Access Consulting  
 Building Compliance  
 Ref: AN019-213829 44-45 Tench Ave Jamisontown  
 Reviewed by: Lucy Alderson  
 Date: 11/12/2019

PROJECT  
 ORANGE FIELDS

CLIENT	MKT CAFE PTY LTD	SCALE	SHOWN@A2	JOB NO.	0461
ADDRESS	44-50 TENCH AVE JAMISONTOWN NSW	DATE	27.09.19	DRAWN	MW
DRAWING NAME	PROPOSED SITE PLAN	DRAWING NO.	02	ISSUE	D

1 SITE PLAN  
 SCALE 1:500 @ A2

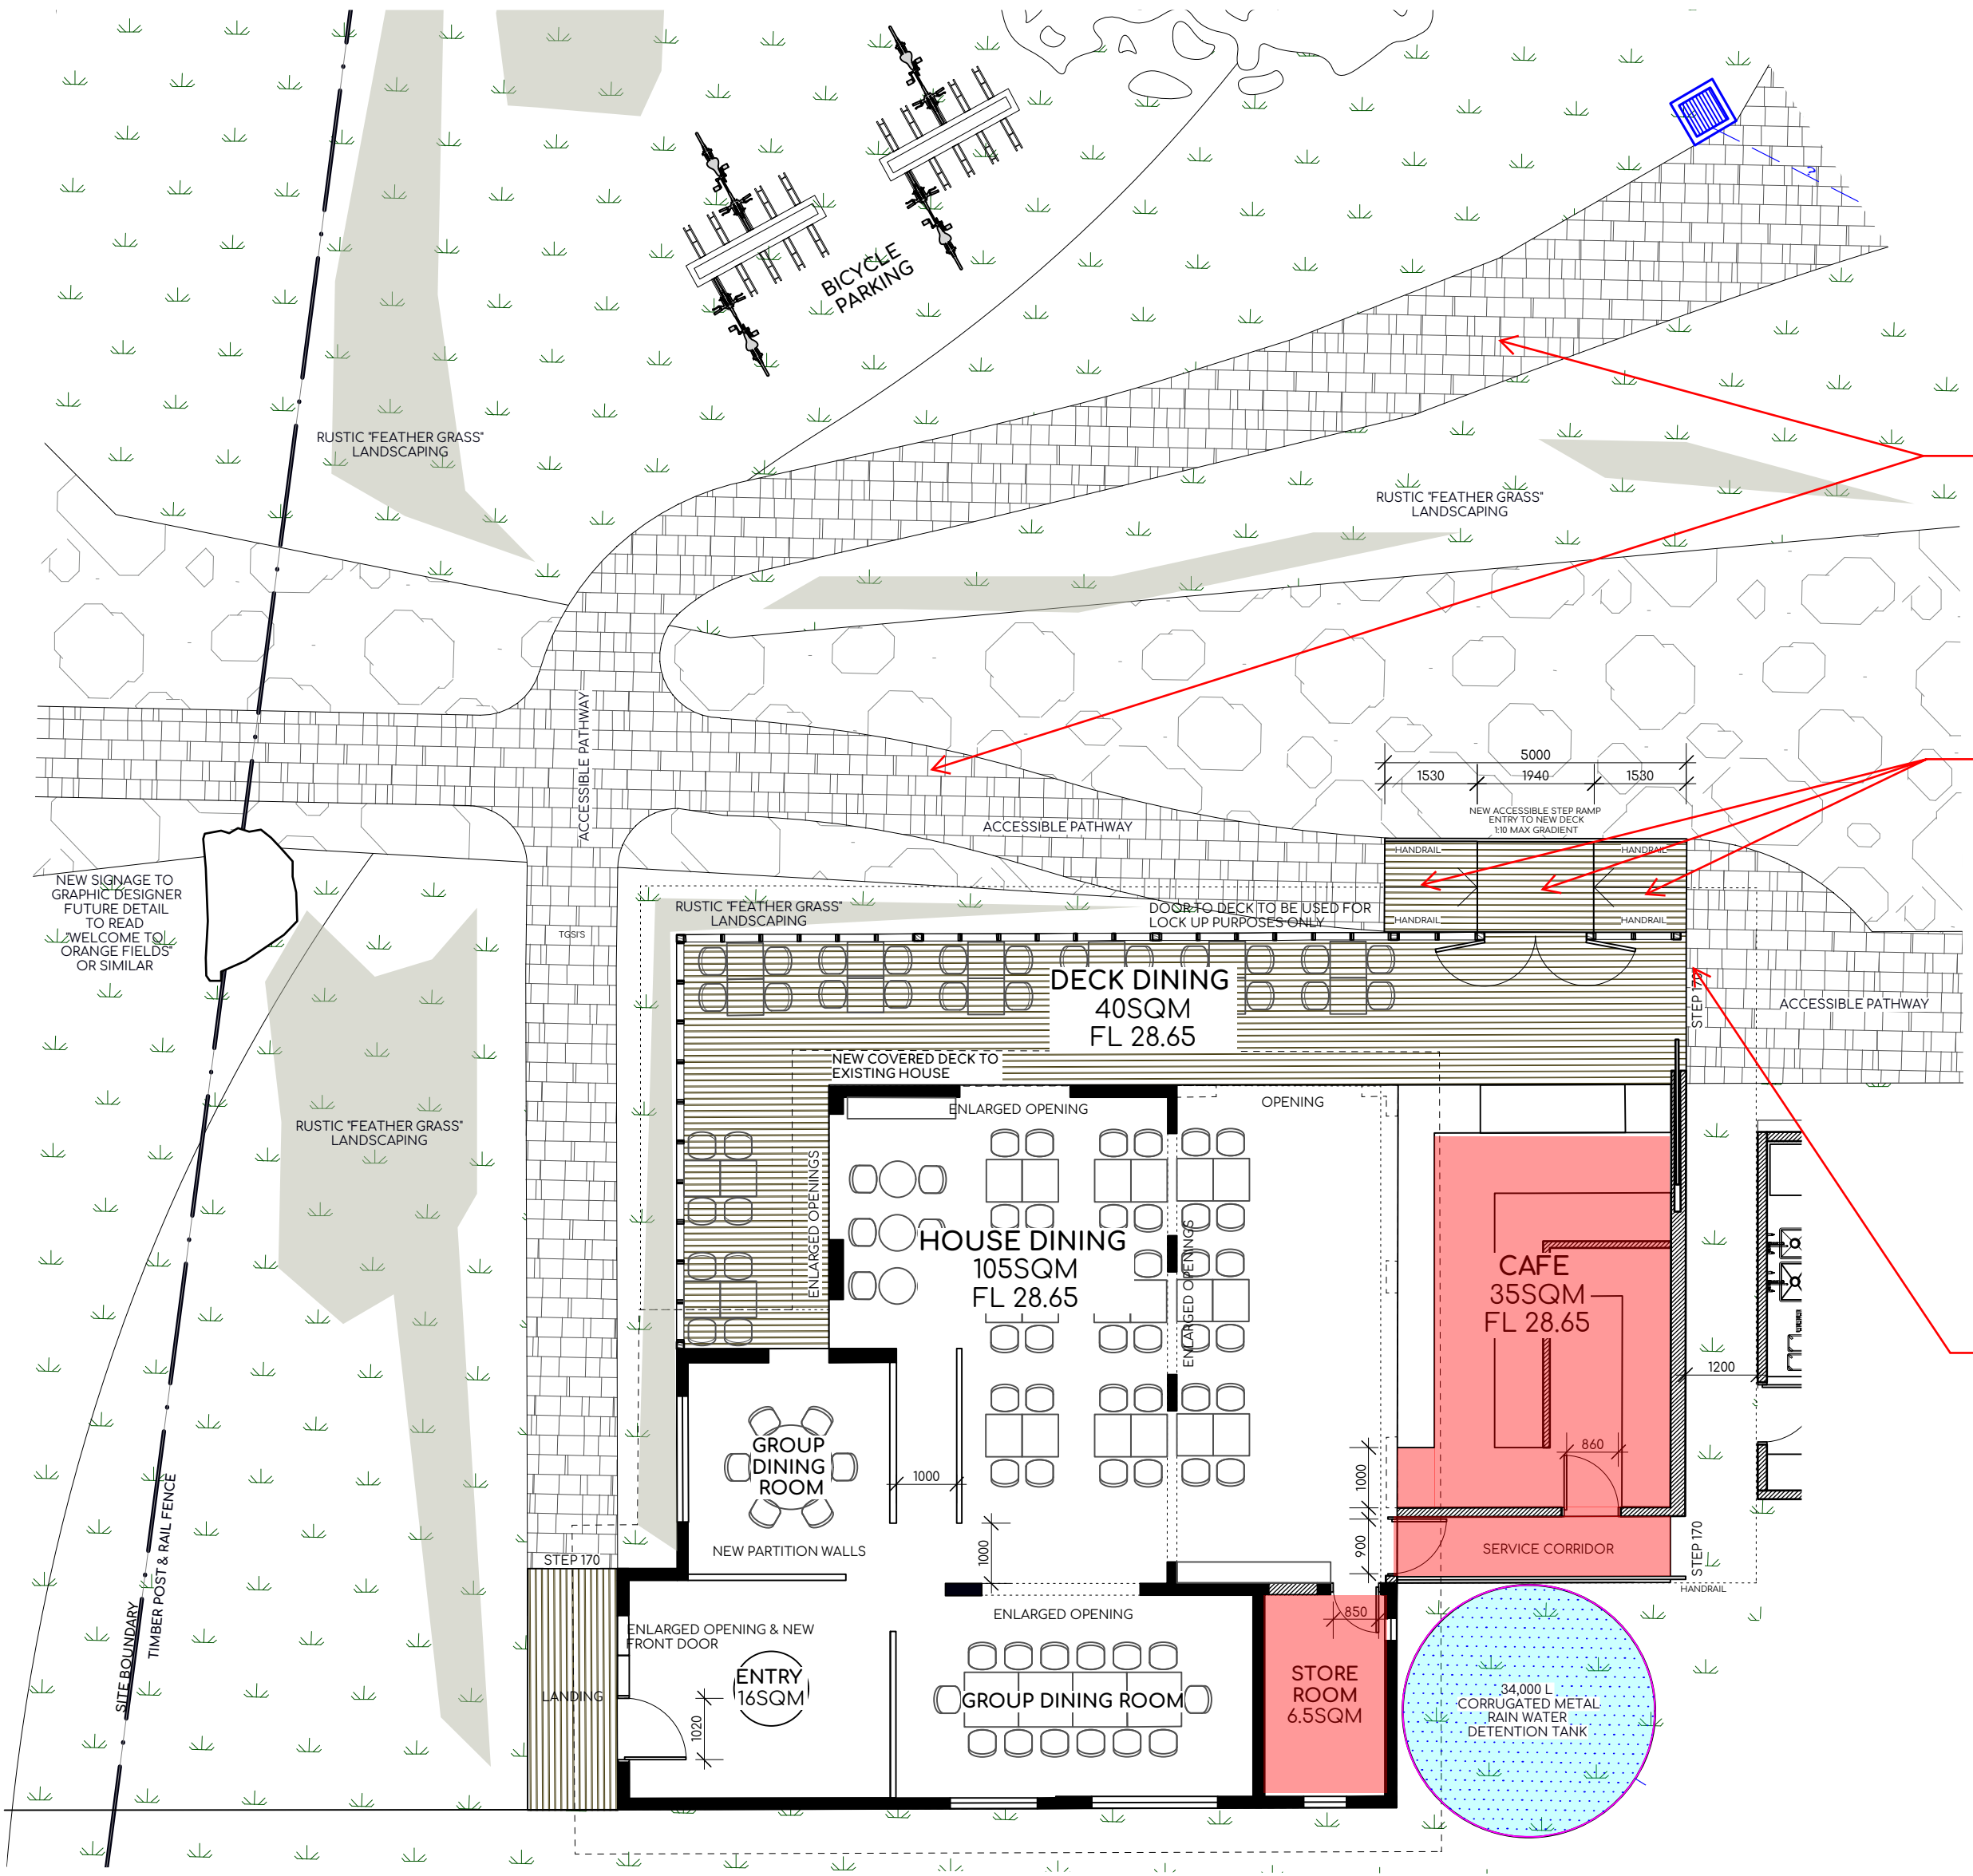
Ensure a continuous accessible path of travel has been provided to all buildings required to be accessible from:

- The main points of pedestrian entry at the allotment boundary; and
- From another accessible building connected by a pedestrian link; and
- From any required accessible car parking space on the allotment. (BCA Clause D3.2)

During subsequent detailed design development stages provide a survey showing proposed RLs for all external linkages within the site boundary for a comprehensive assessment/detailed coordination to comply with BCA D3.2.

**Kerb ramps - AS 1428.1 (2009), Clause 10.7**  
 Kerb ramps at road/path junction shall be aligned in the direction of travel to meet the requirements of with AS 1428.1(2009), Clause 10.7 and Figures 23/24.

During subsequent detailed design development stages provide a survey showing proposed RLs for kerb ramp

1 DETAIL PLAN  
SCALE 1:100 @ A2

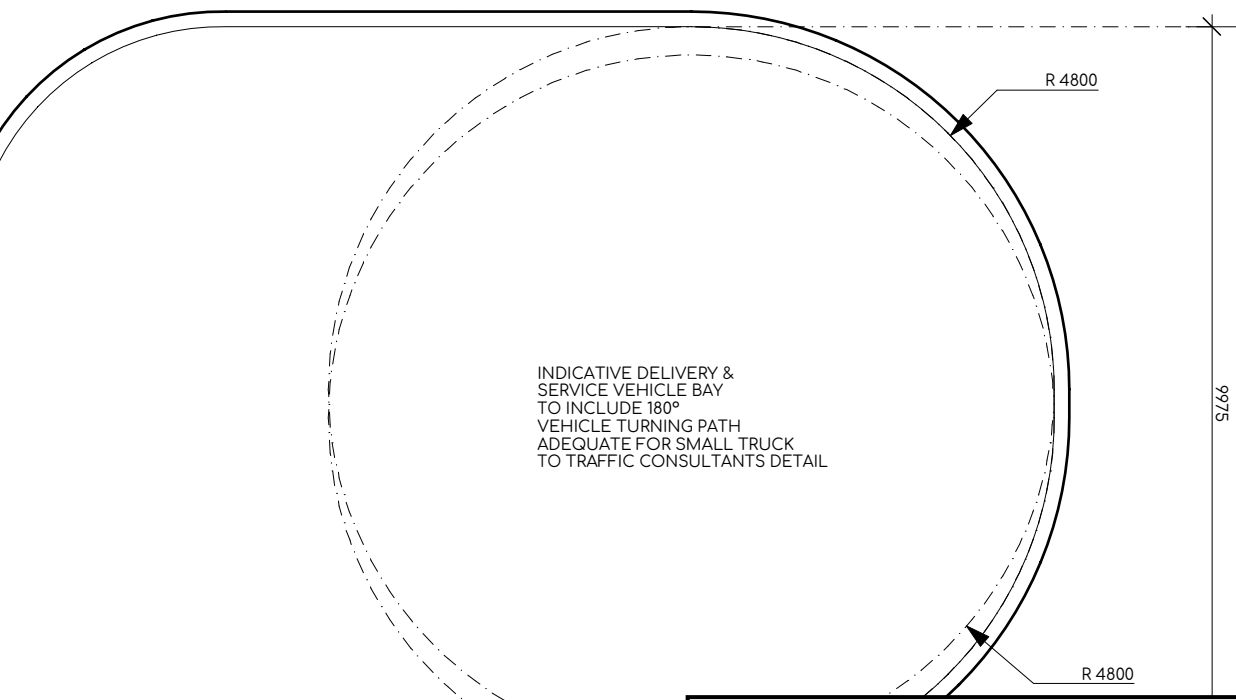
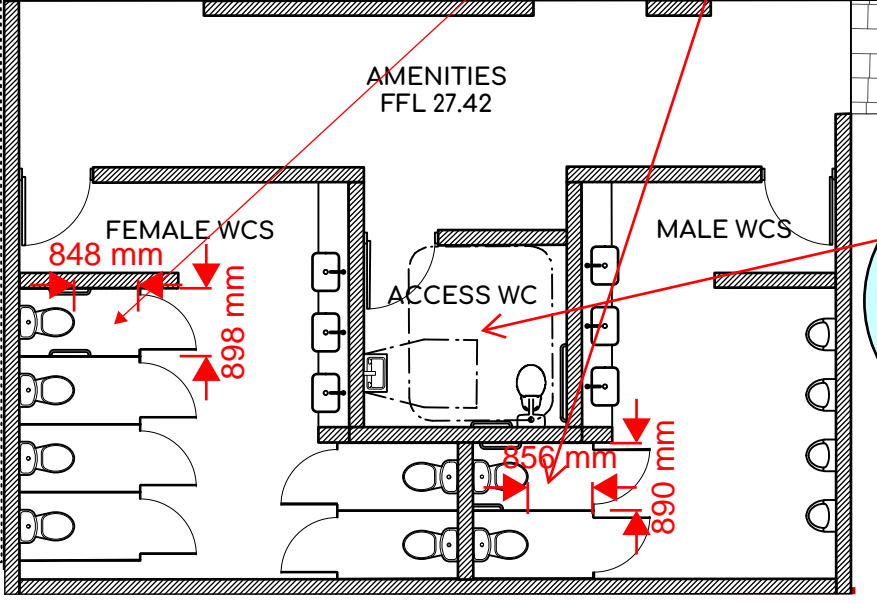
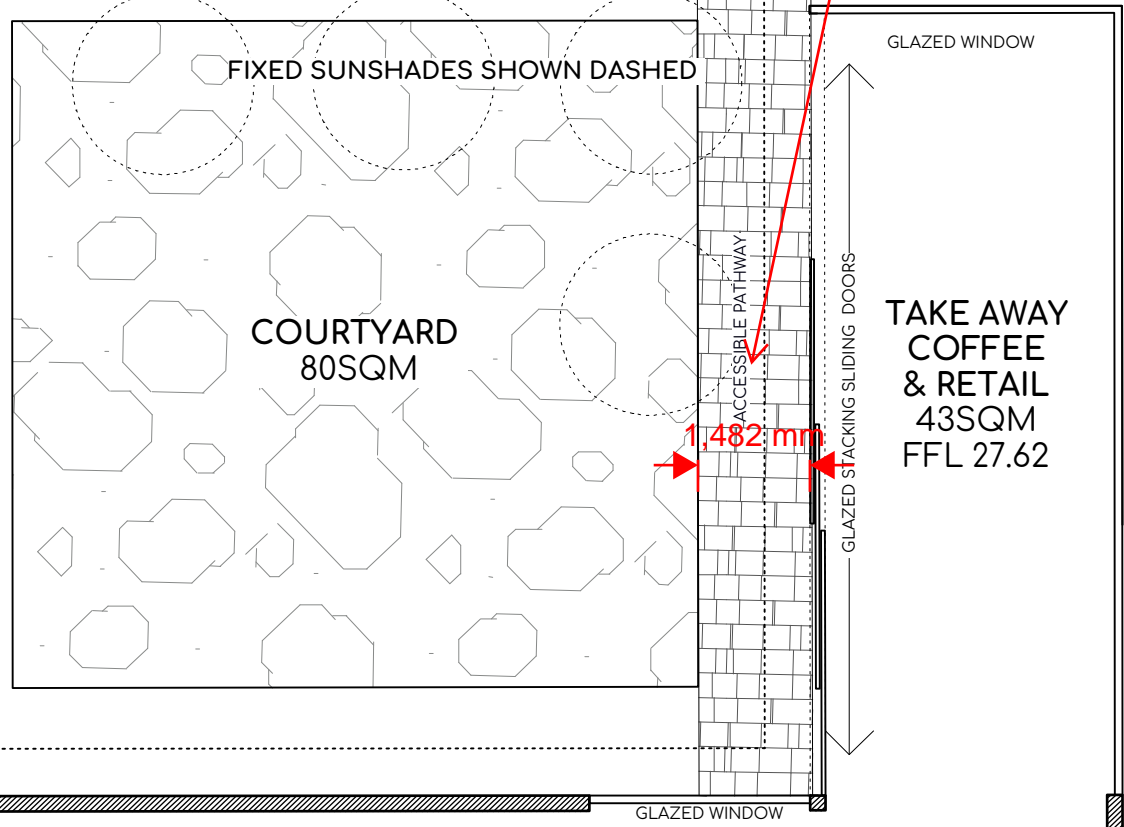
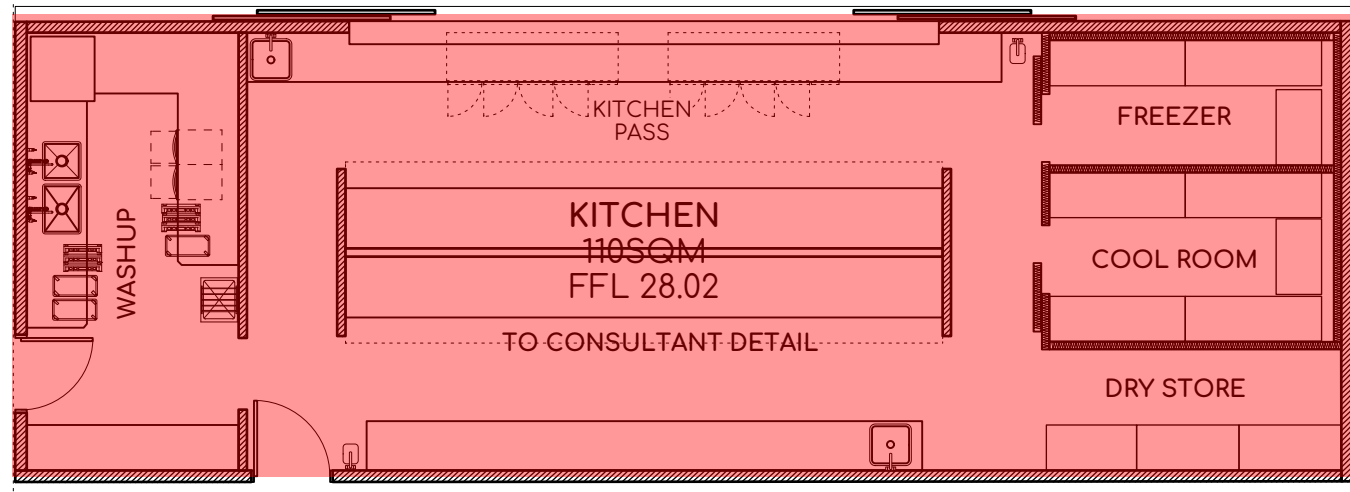
All curved pathways are required to be minimum 1500mm wide.  
- Can Comply

**Access to buildings - D3.2 BCA(2019) (b)**  
In a building required to be accessible, an accessway must be provided through the principal pedestrian entrance, and  
(i) through not less than 50% of all pedestrian entrance including the principal pedestrian entrance  
- Can Comply

During subsequent detailed design development stages provide a survey showing proposed RLs for all external linkages within the site boundary for a comprehensive assessment/detailed coordination to comply with BCA D3.2.

**Step Ramps - AS 1428.1 (2009), Clause 10.6**  
Step ramp shall meet the requirements of AS1428.1 (2009), Clause 10.6 including:  
- Maximum rise of **190mm**;  
- A length not greater than **1900mm**;  
- A gradient not steeper than **1:10**;  
- Minimum 1000mm unobstructed width;  
An open balustrade is provided, a kerb or kerb rail shall be provided to this barrier.

Confirm this entrance is accessible for staff only

The areas filled in red are not required to be accessible:  
(a) An area where access would be inappropriate because of the particular purpose for which the area is used.  
(b) An area that would pose a health or safety risk for people with a disability.  
(c) Any path of travel providing access only to an area exempted by (a) or (b).  
(BCA Clause D3.4).
